# Minutes of **62<sup>nd</sup> PCC meeting**

# EASTERN REGIONAL POWER COMMITTEE

## MINUTES OF 62<sup>ND</sup> PROTECTION SUB-COMMITTEE MEETING HELD AT ERPC, KOLKATA ON 18.12.2017 (MONDAY) AT 11:00 HOURS

#### **ITEM NO. B.1: Tripping of 220 KV Darbhanga-Motipur D/C and 220 KV Muzaffarpur (MTPS)-Motipur D/C on 02-11-17 at 13:18 hrs**

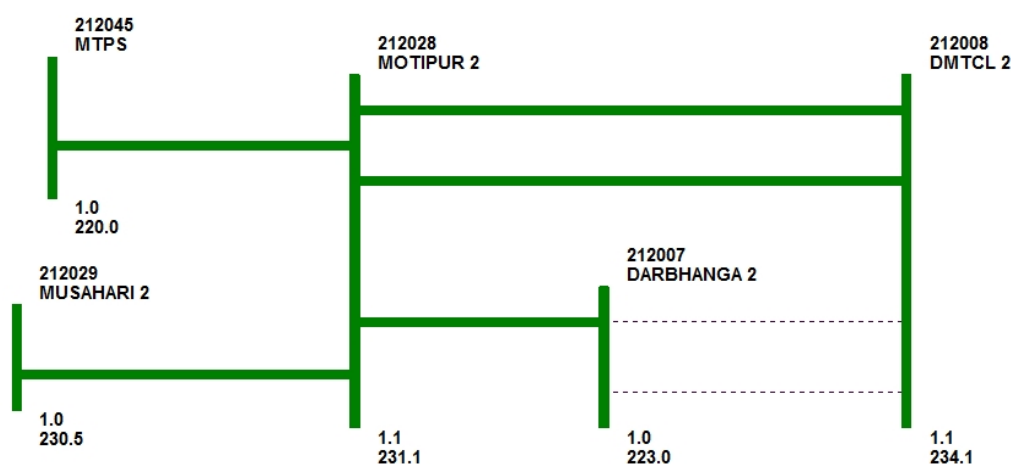
*BSPTCL informed that 220 KV DMTCL-Motipur line 2 tripped from both the ends on Zone 1, Y-B-N fault. But at the same time bus bar protection at 220kV Motipur operated and tripped all the elements connected to 220kV Bus. BSPTCL updated the relay indications as follows:*

PCC opined that the busbar protection should not operate in this case.

BSPTCL informed that the issue of maloperation of busbar protection at 220kV Motipur has been communicated to OEM (GE) for rectification.

### ITEM NO. B.3: Total power failure at 220/132 kV Patratu S/S on 23-11-17 at 11:56 hrs

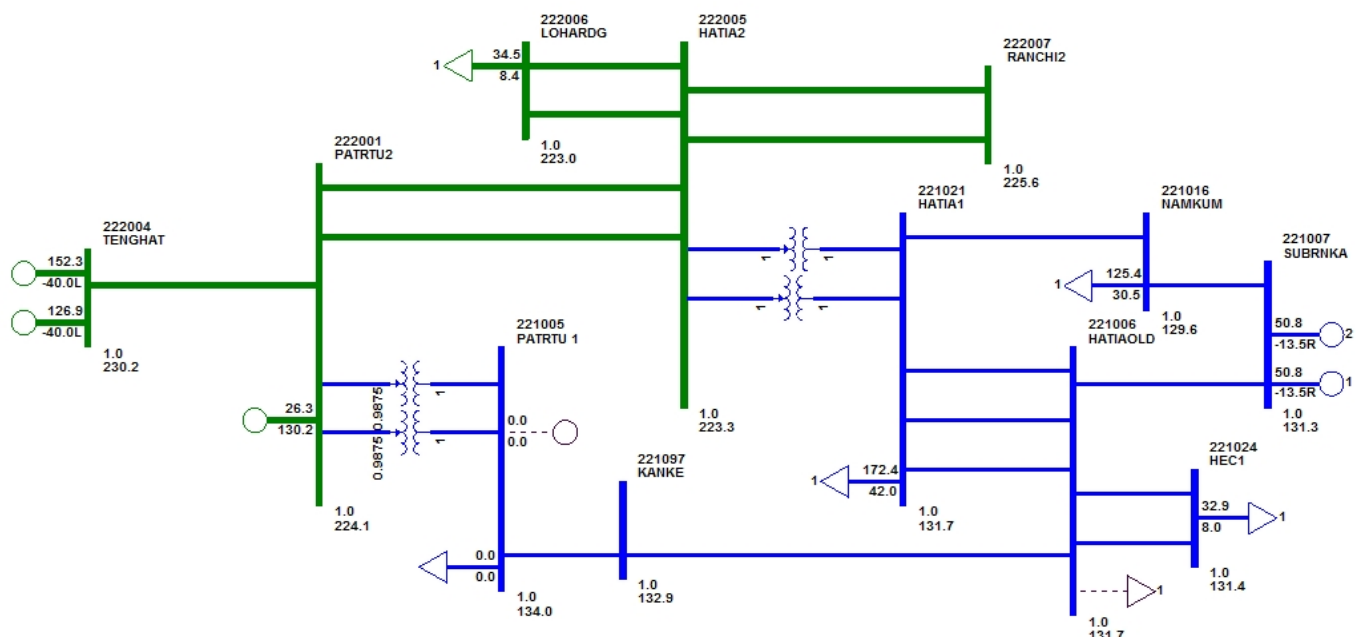
*From the DR plots of Hatia S/s, it was understood that Double Line to Ground Fault (RY-N) occurred near to 220kV bus at Patratu substation. The fault was not cleared from 220kV Patratu S/s. Hence, 220 kV Hatia - Patratu D/C tripped from Hatia end on zone 2. 220kV TVNL-Patratu line tripped from TVNL end on O/C, E/F protection. After tripping of the 220kV lines, 132 kV Hatia-Kanke line got tripped from Hatia end on zone 1.*

*PCC felt that fault in 220kV Patratu S/s should be cleared by Busbar protection but no protection relay has operated including 220/132kV ATRs at 220kV Patratu S/s. Hence the fault got cleared from 220kV Hatia, 220kV TVNL and 132kV Hatia old.*

*PCC advised NTPC to collect the details from Patratu and explain the reason for non-operation of any protection system at 220kV Patratu S/s in next PCC meeting.*

**ITEM NO. B.4: Total power failure at 400/220 kV Alipurduar S/S on 26-11-17 at 04:34 hrs**

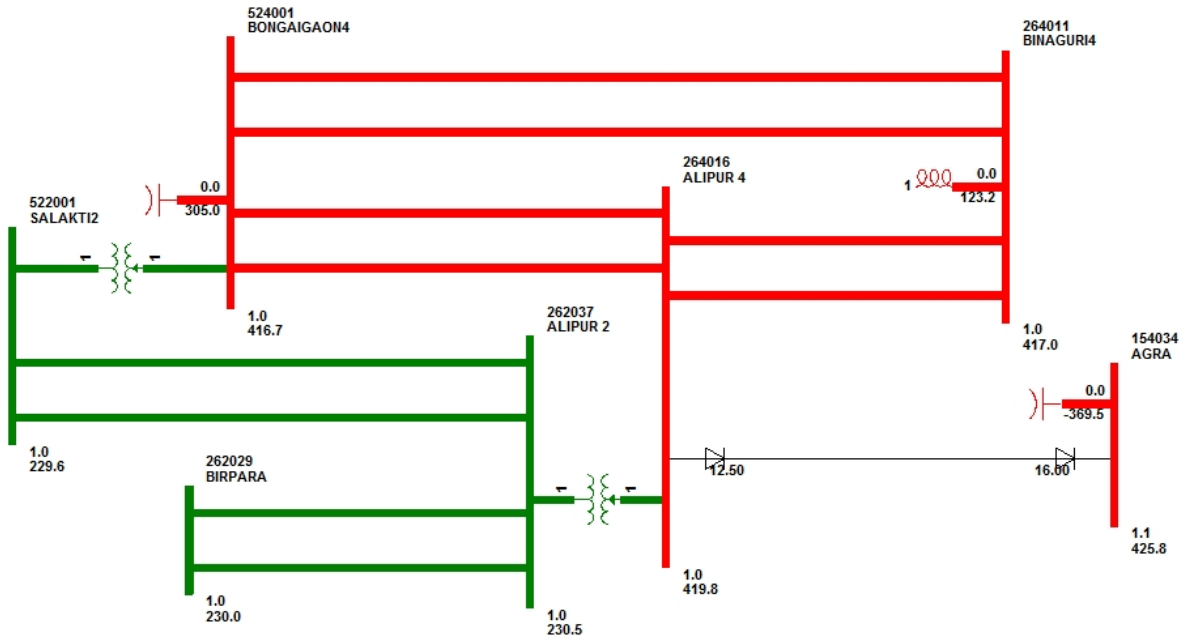
1. As per the DR all 400 KV lines O/V pick up and tripping took place at 251KV line to Neutral voltage which corresponds to 434 KV line to line voltage. And 460 KV voltage appear after tripping of all 400 KV line. So settings need to be checked. As per verbal communication, they confirms that stage one setting is 110 % with time grading for parallel lines and after the incident they have tested the overvoltage relay and got 439.87 KV pick up and 438.1 KV droop down voltage . But this need to be checked.

2. From HVDC DR it is not clear which block signal was issued. For pole 4 AC under voltage was picked up 200 ms after DC power zero. So 1st power become zero the low Ac voltage detected but no blocking command is seen from DR. Same for pole 3 it is not clear. In both the case TFR is triggered but within the time window of DR no blocking signal issued. POWERGRID is asked to submit complete event recording.

3. Reason for voltage rise after tripping of all 400 KV line is not clear. Though there were some filter switching but capacity wise total MVAR capacity of filters were same before switching and after switching. And MVAR injection only increased in accordance with bus voltage increase. So cause of bus voltage increase need further analysis. Now one possibility could be drastic fault level reduction of Alipurduar after tripping of all 400 KV line. At that point of time it was connected to the grid via 220KV Birpara double circuit line and at that moment 3 filters of filter bank 1 (410 MVAR) was in service (this is as per minimum filter requirement for controlling harmonics injection to the grid). That's why with this low fault level voltage rises abruptly. In PSSE also we found similar result i.e in steady state with all 400 KV line open, with 300 MW power order in HVDC and 3 filter of filter bank 1 in service voltage of 400 KV bus at Alipurduar is rising similarly.

*Powergrid has shown the DR plot of over voltage trippings of 400 kV Alipurduar - Bongaigaon - I, 400 kV Alipurduar-Binaguri D/C and 220 kV Alipurduar - Birpara D/C line. Powergrid explained that relay has operated correctly as per the settings.*

*PCC felt that the over voltage settings at 400 kV Alipurduar S/s should be reviewed to avoid simultaneous tripping of transmission lines.*

*PCC opined that in view of HVDC connectivity from 400kV Alipurduar S/s, proper system studies should be done for any changes in the over voltage settings.*

*PCC advised Powergrid to refer the issue of reviewing the overvoltage settings at 400kV Alipurduar S/s to their corporate office.*

**ITEM NO. B.7: Disturbance at 400kV Sasaram on 29-11-17 at 17:19 hrs**

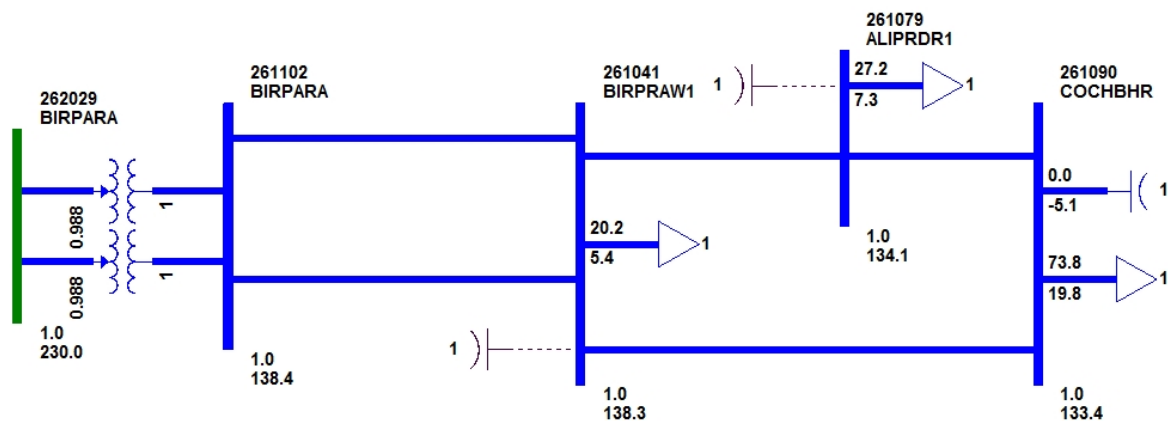
*Powergrid explained that heavy flash over was observed at 17:19 Hrs during opening of 125MVAR, Bus Reactor-I, Isolator (413-89 BR). On inspection it was found that the B- phase, Tie breaker (414 -52) got stuck however the auxiliary contacts were in open position. Due to the heavy flash over, R-N fault occurred in 400kV East side bus -II. Tie bay LBB protection operated and tripped 400 kV*

Sasaram - Biharshariff – II which was connected to same dia. Severe voltage raise also observed in R-ph due to the flash over resulted in tripping of 400KV, 315MVA ICT –II on over flux and HVDC system on over voltage.

Powergrid added that the action has been taken for supply and service of ABB make 400 KV Circuit Breakers.

#### ITEM NO. B.9: Disturbance at 400/132kV Motihari S/s.

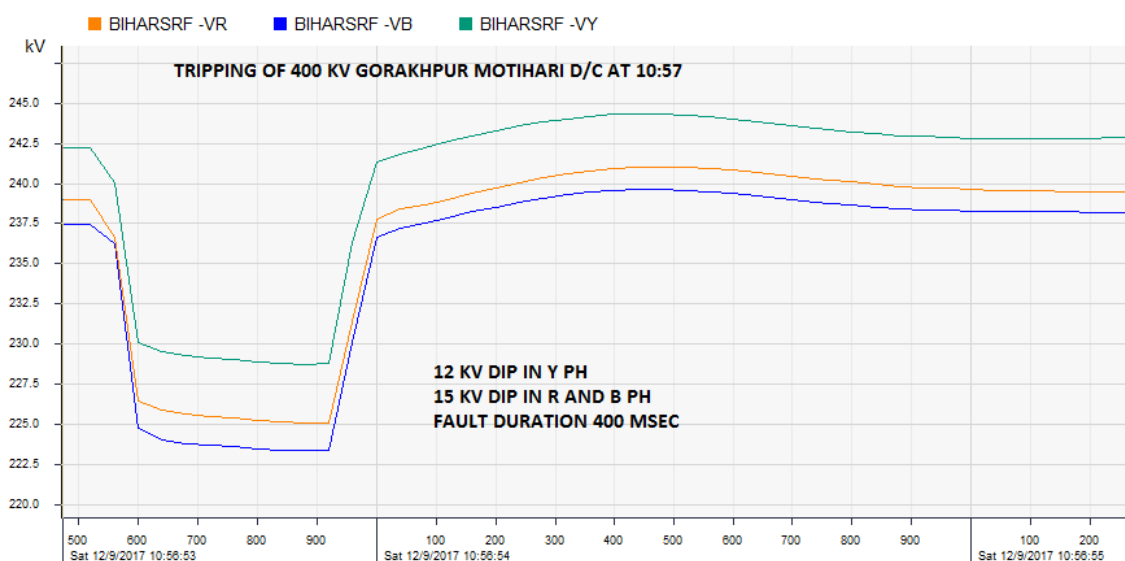
1. Reason for grounding of earth switch may be discussed. As there are more than one interlock present to avoid this type of operating mistakes.

- Reason for operation of bus bar protection of both buses may be explained as fault was only at bus II
- In PMU data, delayed clearance fault has been observed. In case of operation of bus bar protection, fault should be cleared instantaneously.

TRIPPING INCIDENT OF 220 kV PTPS DATED- 23 NOV 2017

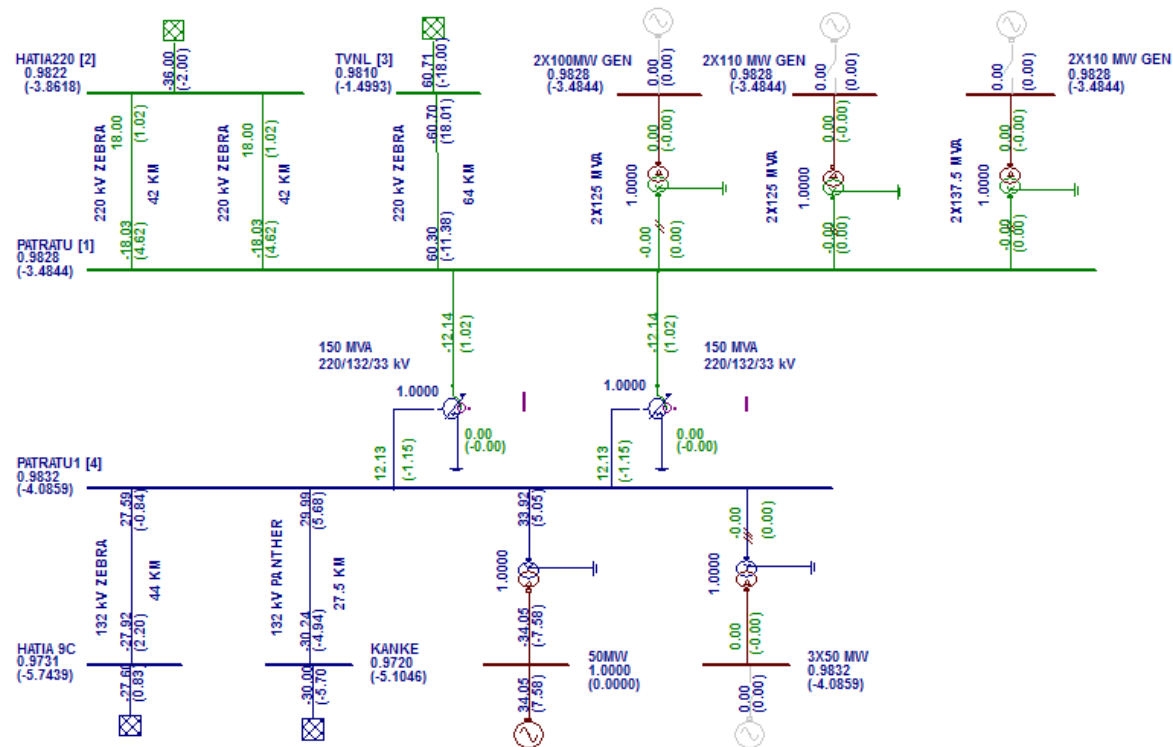
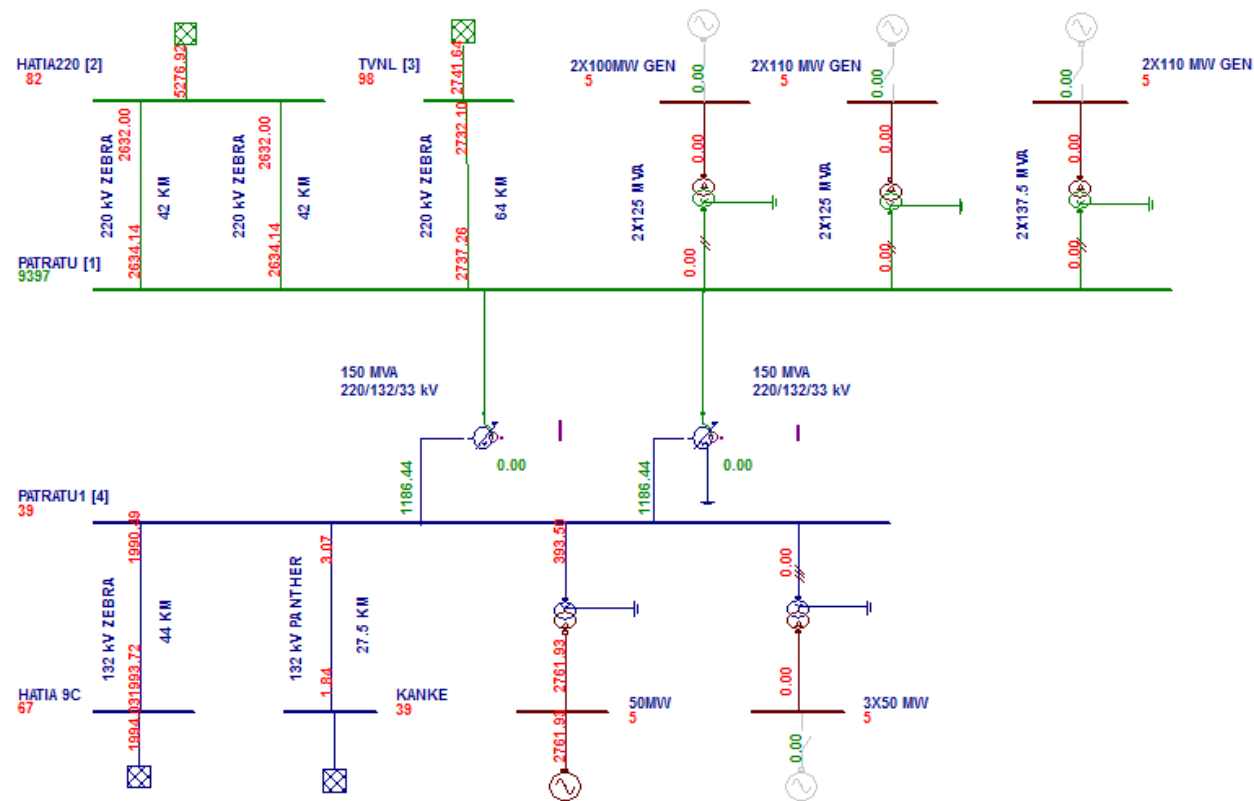
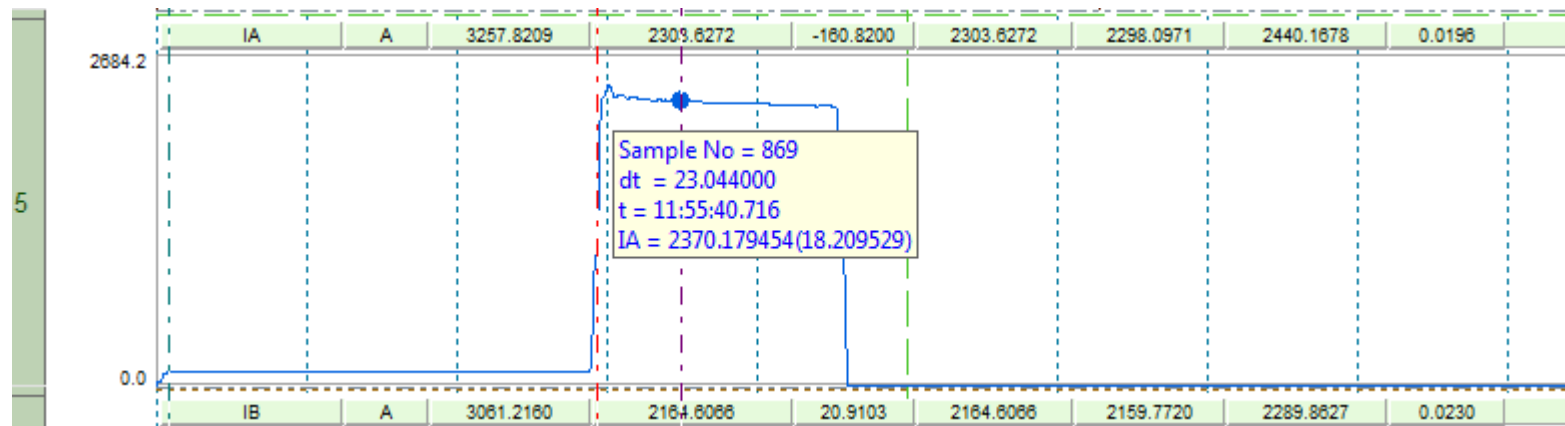
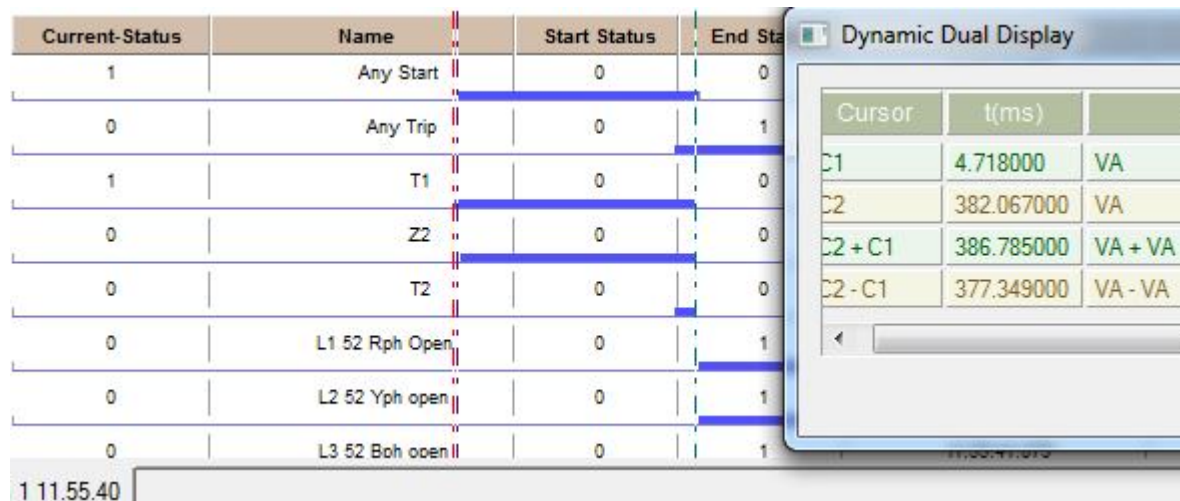
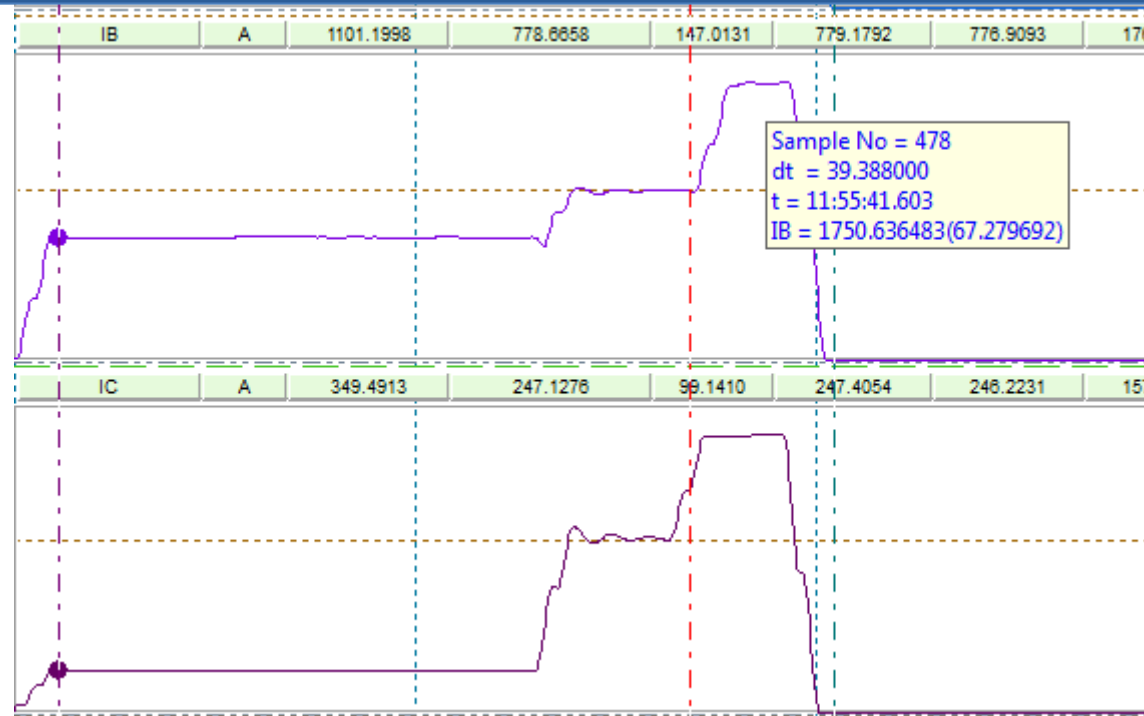
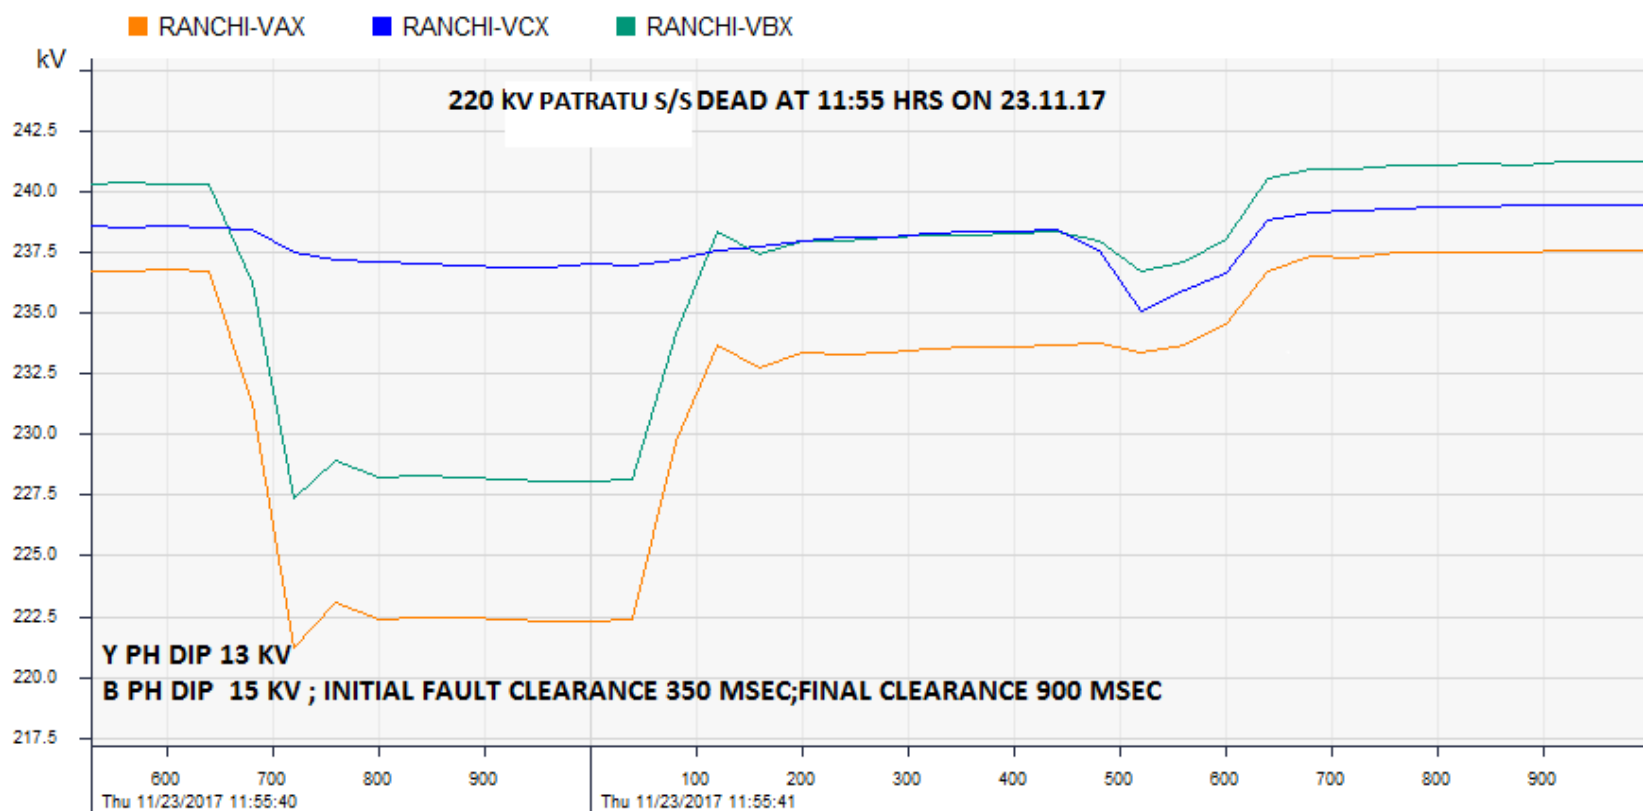
- Short-circuit study is carried out to match fault current with disturbance recorder.
- A Double Line to Ground Fault was created near to 220kV bus at PTPS substation.
- Fault current contribution from Hatia each 220kV Circuit is around 2634A which is comparable with DR obtained from Hatia 220kV end.

- Relay sensed fault and sent trip signal after 350mSec Delay time.
- All R, Y & B Phase breaker opened after 377mSec and current reduced to 0.

- Current in A,B Phases rise rapidly to 1kA and after 320mS it again raised to 1.5kA and changed into 3Ph-G Fault which suggesting fault current feeding from Kanke was increased after 220kV Lines got tripped ie app after 350mS from fault.
- Later Relay sensed fault and tripped after 50mS

Fault observed in PMU is around 350mS
